SUBJECT: Application for amend to license NPF-63, requesting rev to TS
 4.8.1.1.2.h.2 re to test tanks & non-isolable piping at this
 test pressure.

SERIAL: HNP-96-209
10 CFR 50.90

SHEARON HARRIS NUCLEAR POWER PLANT
DOCKET NO. 50-400/LICENSE NO. NPF-63
REQUEST FOR LICENSE AMENDMENT
DIESEL FUEL OIL SYSTEM PRESSURE TESTING (A.C. SOURCES - OPERATING)

DIESEL FUEL OIL SYSTEM SCHEMATIC

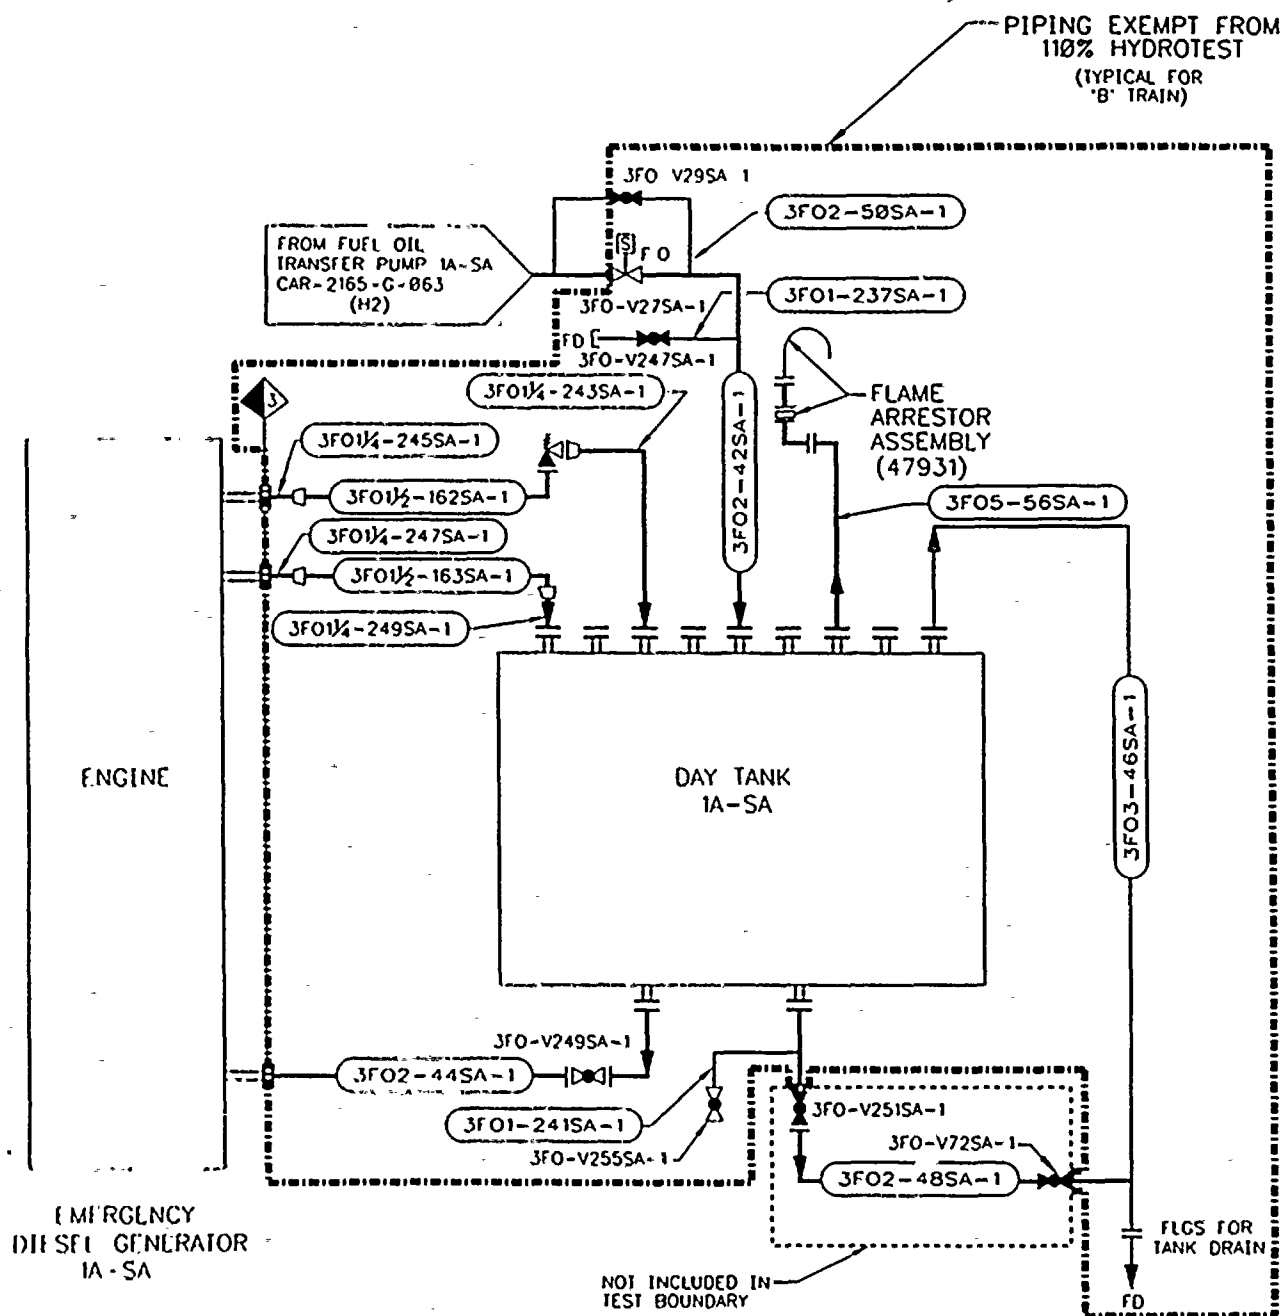
The exemptions allowed by ASME Code Section XI will be invoked for the atmospheric day tank and non-isolable piping as identified in the attached schematic.

PIPING EXEMPT FROM 110% PRESSURE TEST
(TYPICAL)

In accordance with existing commitments, CP&L will continue to perform inservice inspection and testing of the diesel fuel oil system in accordance with the ASME Boiler and Pressure Vessel Code, Section XI. Based on Section XI, IWD-5223 exemptions discussed above, pressure testing at 110% of the system design pressure will only be required on the isolable portions of:

- fuel oil transfer pump discharge piping to the day tank, and
- fuel oil supply line from the day tank to the diesel vendor-supplied piping, and
- fuel oil return piping from diesel vendor-supplied piping to the day tank regulator valve.
